MEMORANDUM

RE: **150 High Rocks Road – Metheny Visual Assessment**
(SBL – 7.2-5-2.100)

DATE: January 23, 2024

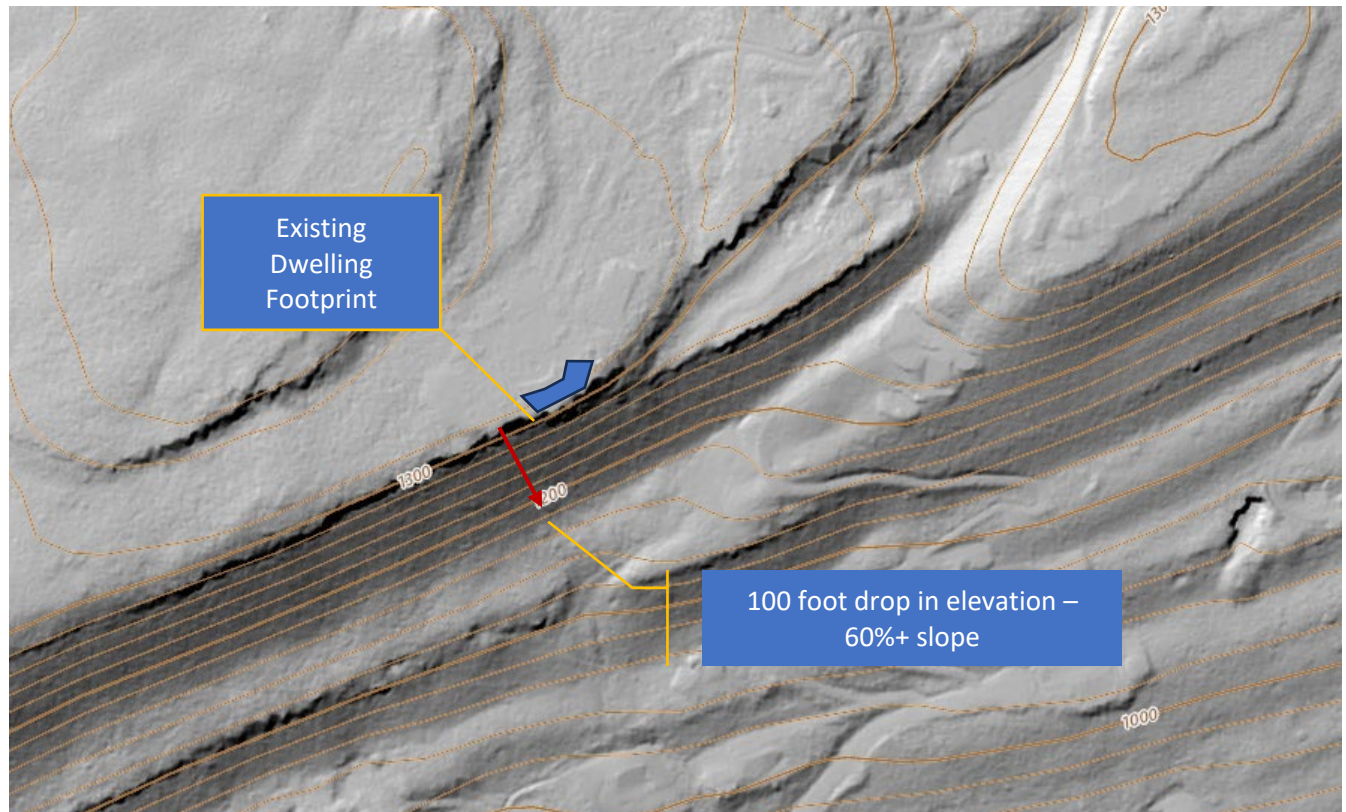
on Ohayo Mountain. The property borders the Town of Woodstock along its northerly boundary. Note that the aerial photo does not correctly show the property boundaries. A tennis court is present on the site, although not shown on the plot plan. The Building Inspector has opined that two of the proposed buildings are subject to visual assessment – the new barn and the new dwelling) including barn to be attached to it). The Building Inspector has determined that the existing structure is not subject to Planning Board review. See our comments below.
